BUILDING PERMIT REPORT

DATE: 25 June 2001 ADDRESS: 93 M. L. TON STREET CBL: 336-H-033
REASON FOR PERMIT: To Construct a 24'x25' attached private garage
BUILDING OWNER: P. E. M. Lewis
PERMIT APPLICANT: CONTRACTOR SAO
USE GROUP: R-3 CONSTRUCTION TYPE: 5B CONSTRUCTION COST: 12,325 PERMIT FEES: 100.00

Paul Lewis
 93 Milton St. 26' x 24'
 Attached Garage Additions

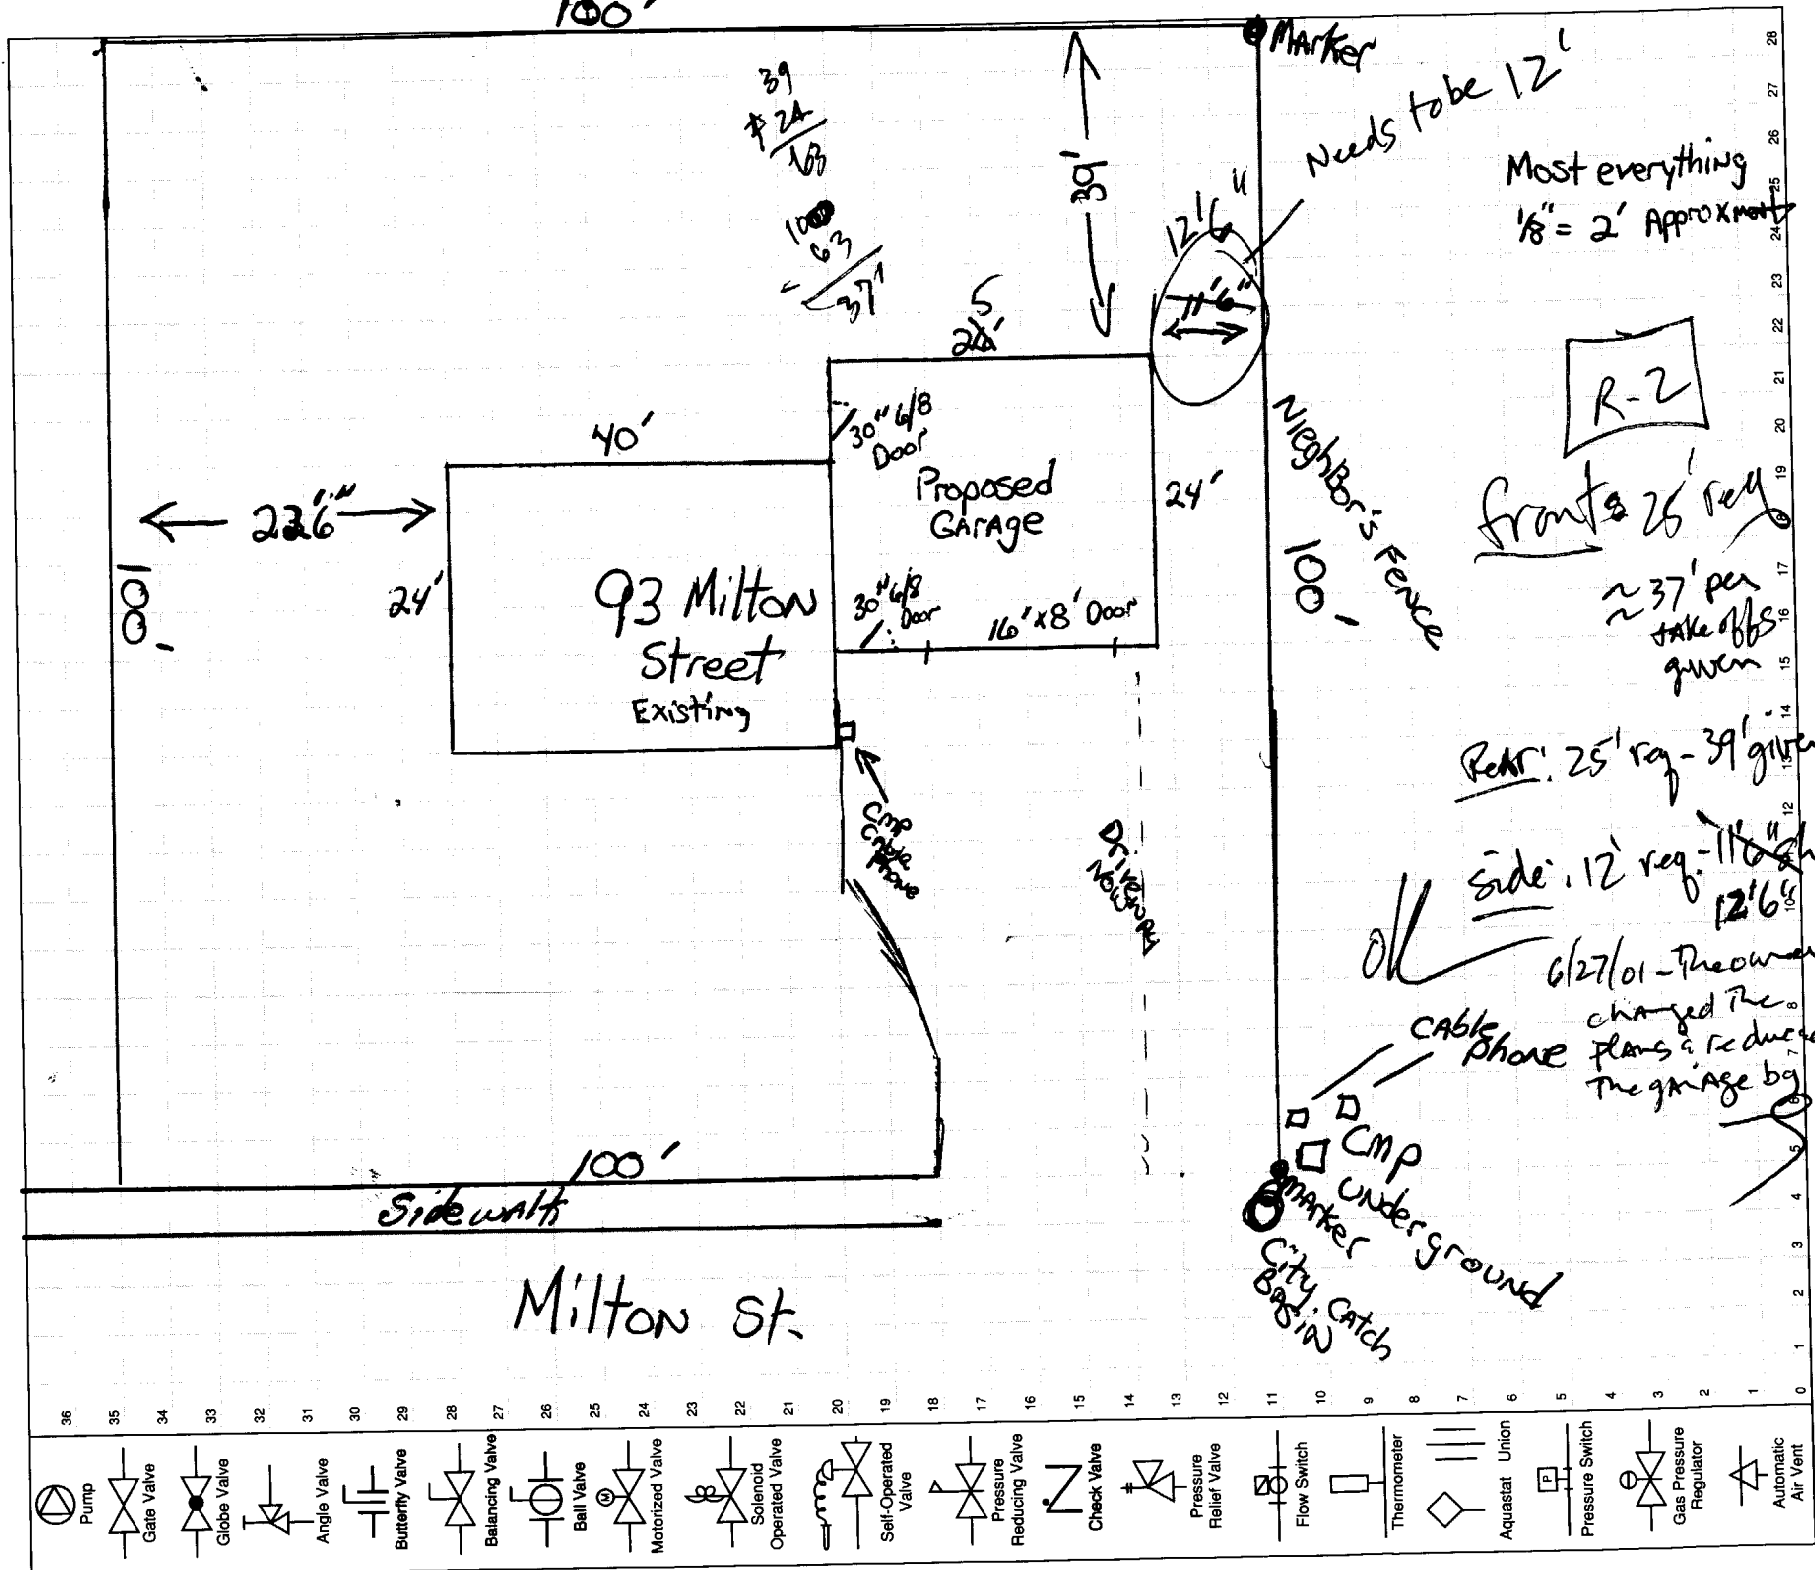
32. Please read and implement the attached Land Use Zoning report requirements. *Approval is based upon our 6/27/00 phone conversation where the owner agreed to reduce I*

33. Boring, cutting and notching shall be done in accordance with Sections 2305.3, 2305.3.1, 2305.4.4 and 2305.5.1 of the City's Building Code. *garage width by one (1) foot. 0.5*

34. Bridging shall comply with Section 2305.16. *The side setback is 12'6"*
- X 35. Glass and glazing shall meet the requirements of Chapter 24 of the building code. (Safety Glazing Section 2406.0)
